Parking Lot Specialties Expansion – Site Plan

City of Carlisle, Iowa

FOX Engineering & City Staff have completed the second review for the Parking Lot Specialties Site Plan submittal dated 11/9/21 and submitted by email on 11/10/21 and offer the following comments:

Parking Lot Specialties – SITE PLAN - 210106

PARKING LOT SPECIALTIES - ADDITION
CARLISLE, IOWA
OVERALL GRADING PLAN

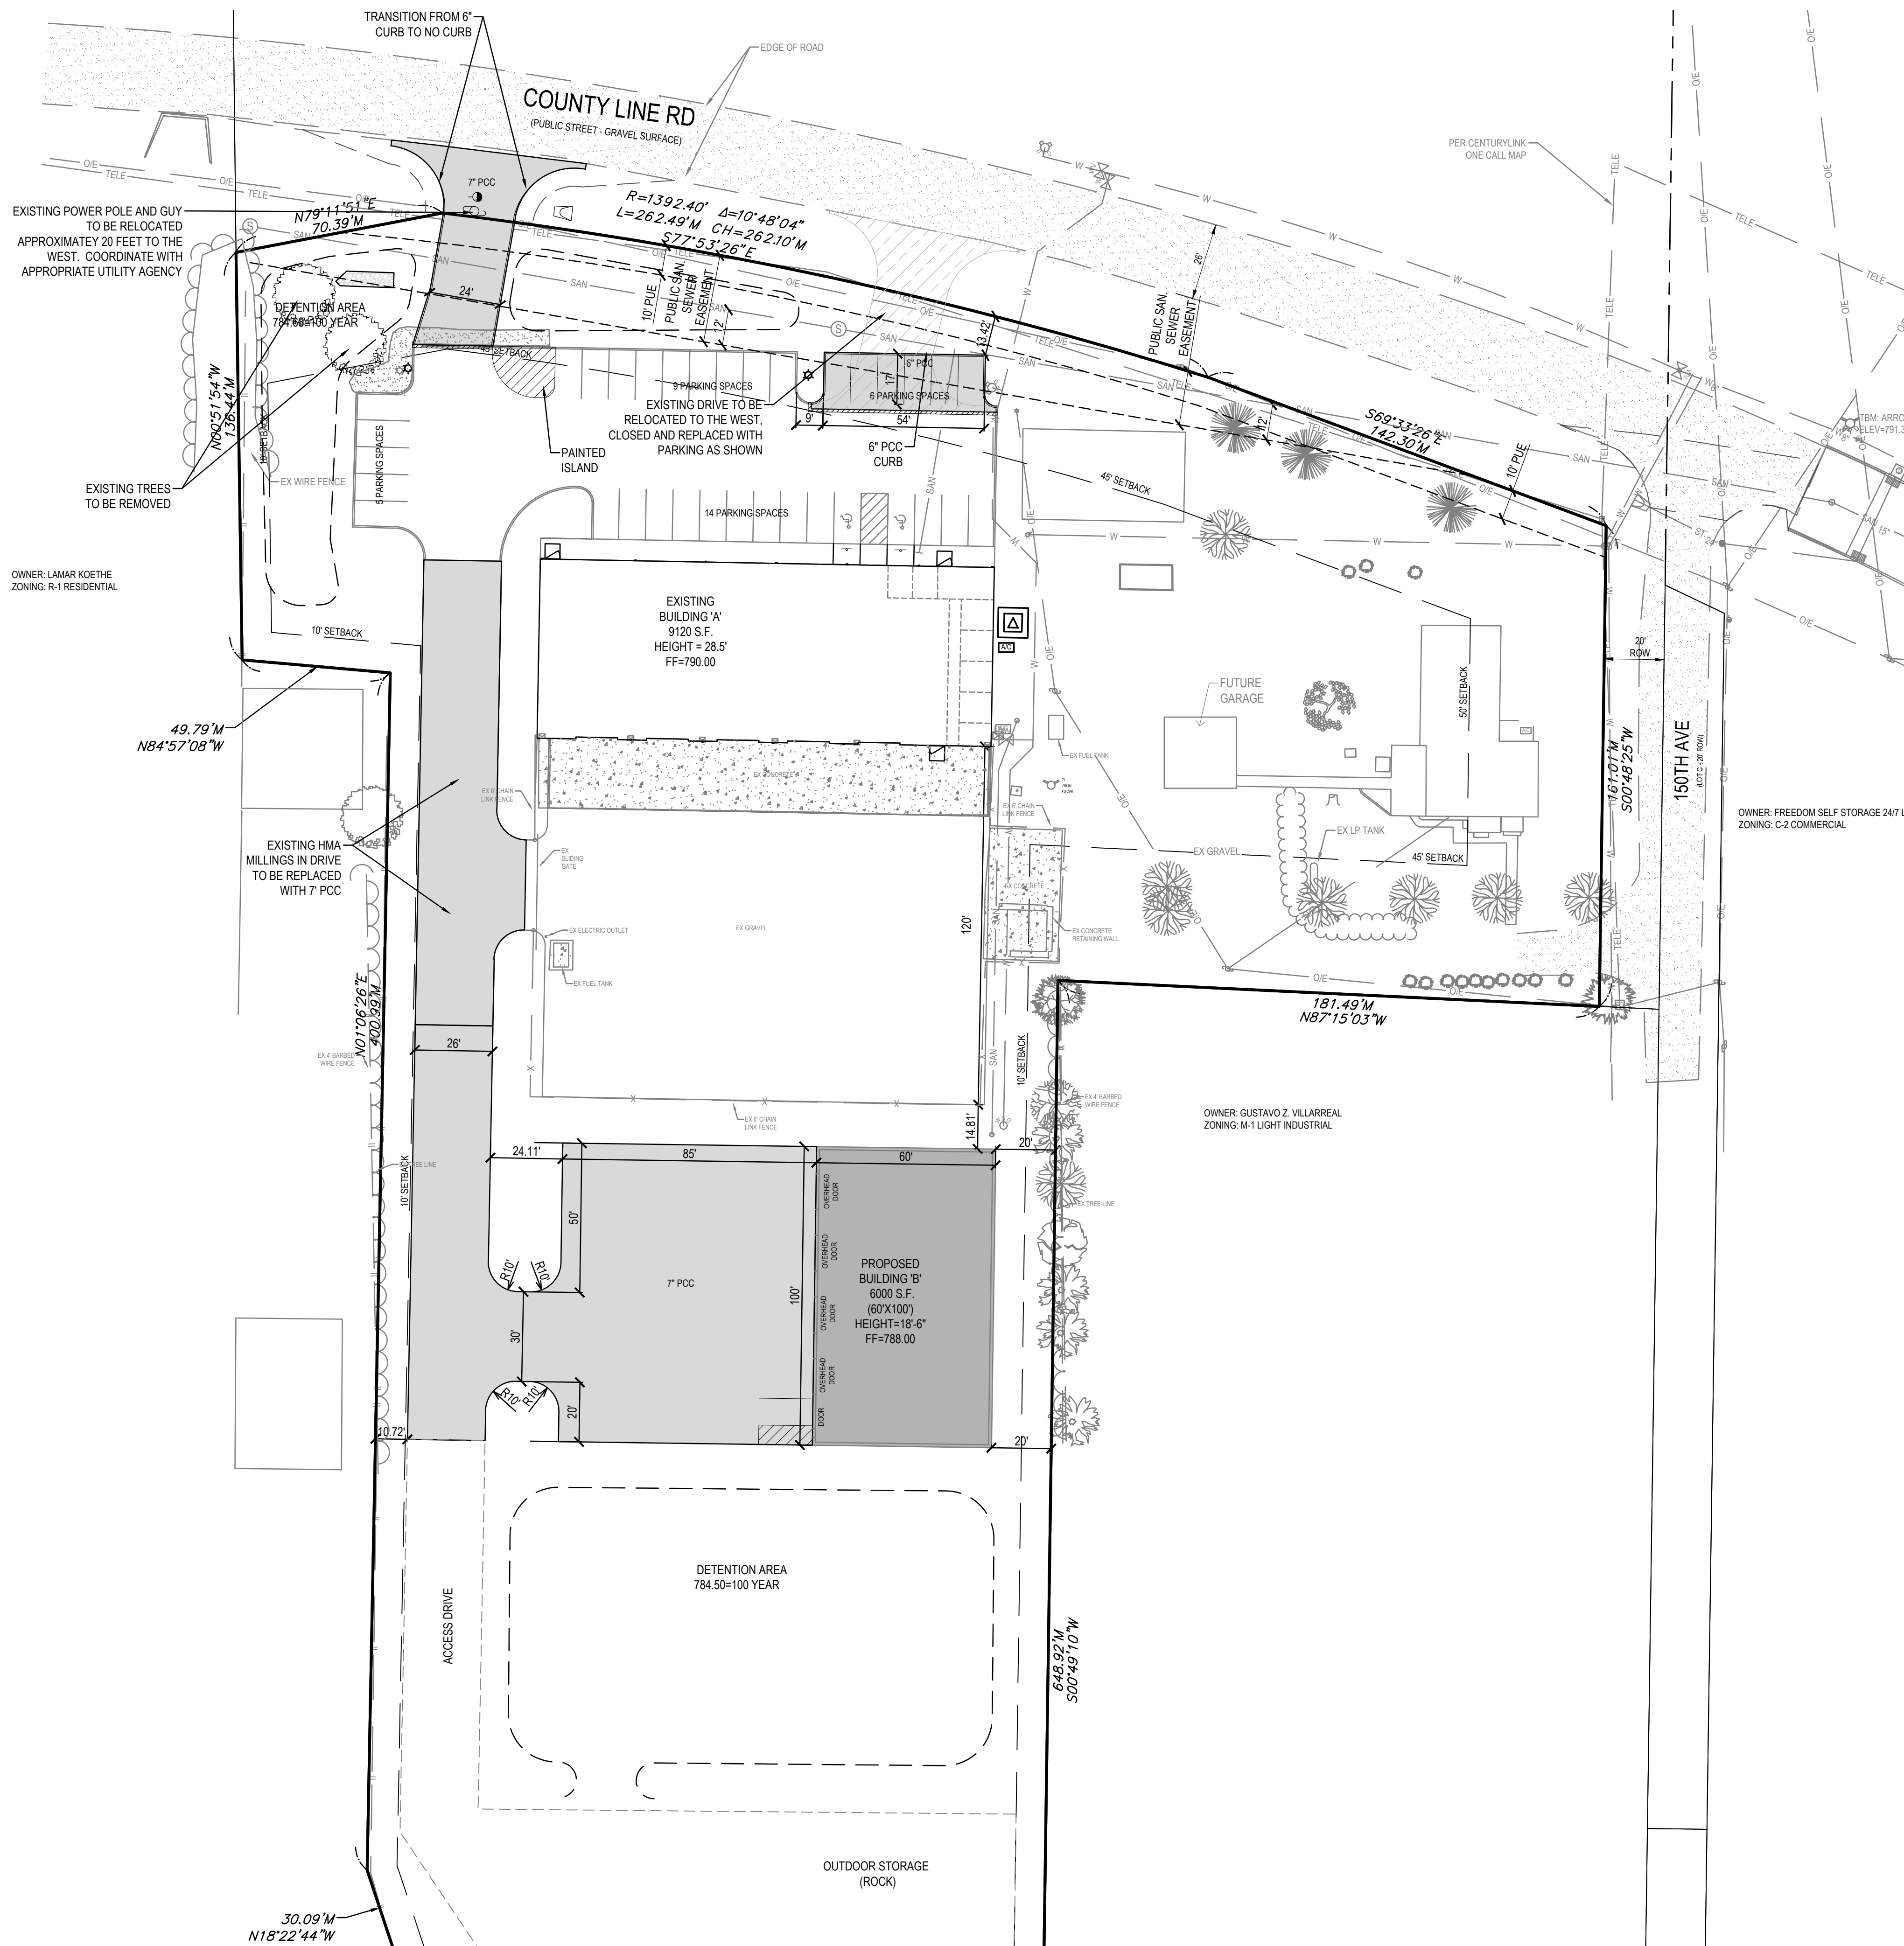
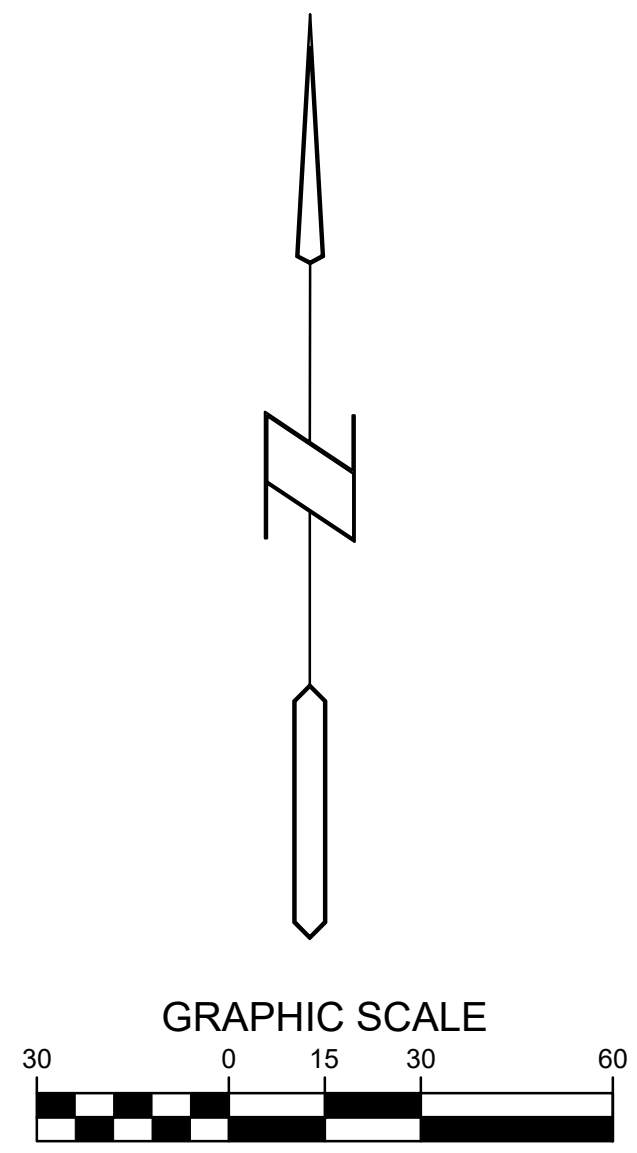
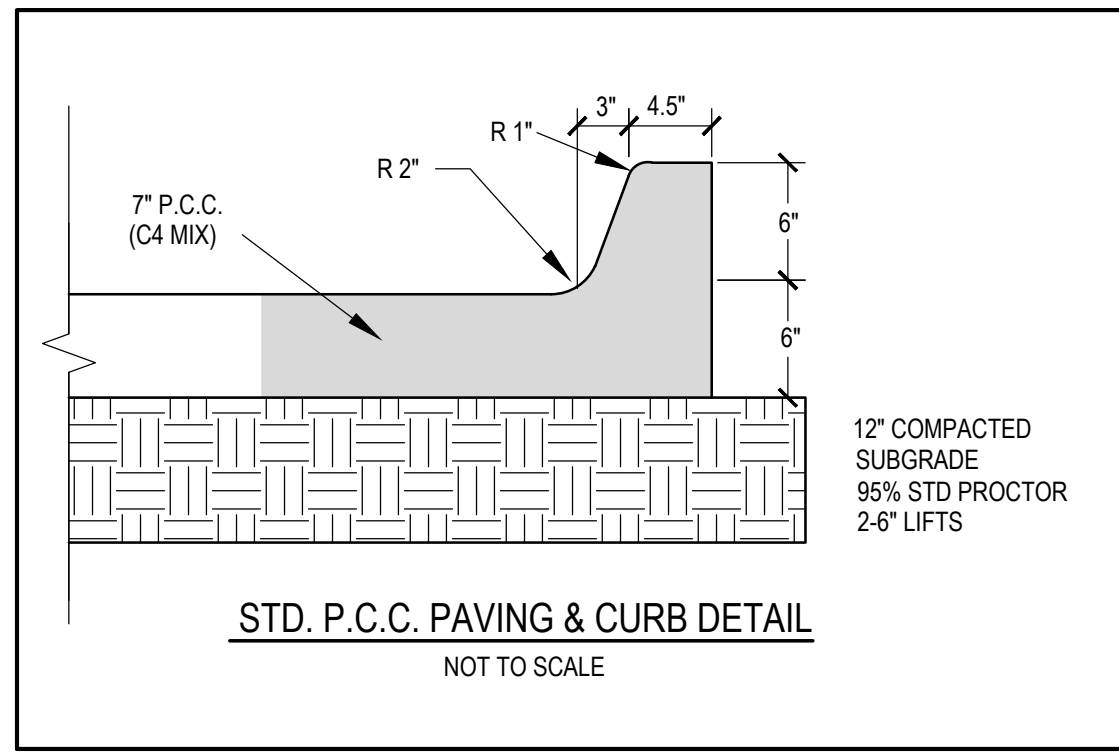
Sheet C3.1 – Grading & Utility Plan

11. Please label and dimension the width of the overflows for the detention area in the front yard (including elevation).
12. Please label the sanitary cleanout rip and flowline. Also, please label the storm/sanitary conflict.
13. Please show hydrant coverage radii (150-ft). It appears that another hydrant is required to cover the new structure to meet 165.06, 5, L, 2 of the Code.

Sheet C3.1 – Grading & Utility Plan

22. The referenced water/sewer pipes were installed as part of the Phase 1 project for the future addition
23. The downspout locations have been noted and will discharge to splash block and directed to onsite detention
24. The proposed overflows have been labeled and dimensioned
25. Typical longitudinal grades/slope arrows for the detention areas have been called out
26. A 6-foot earthen shoulder has been provided with spot elevations added
27. The rim and approximate inverts have been called out for the existing sanitary cleanouts
28. Hydrant coverage radii have been provided for the existing hydrants
29. Erosion control (scour stop) has been called out for the 12" FES within the public right-of-way
30. A note has been added calling out footings and apron guards for the flared ends
31. An orifice detail has been added
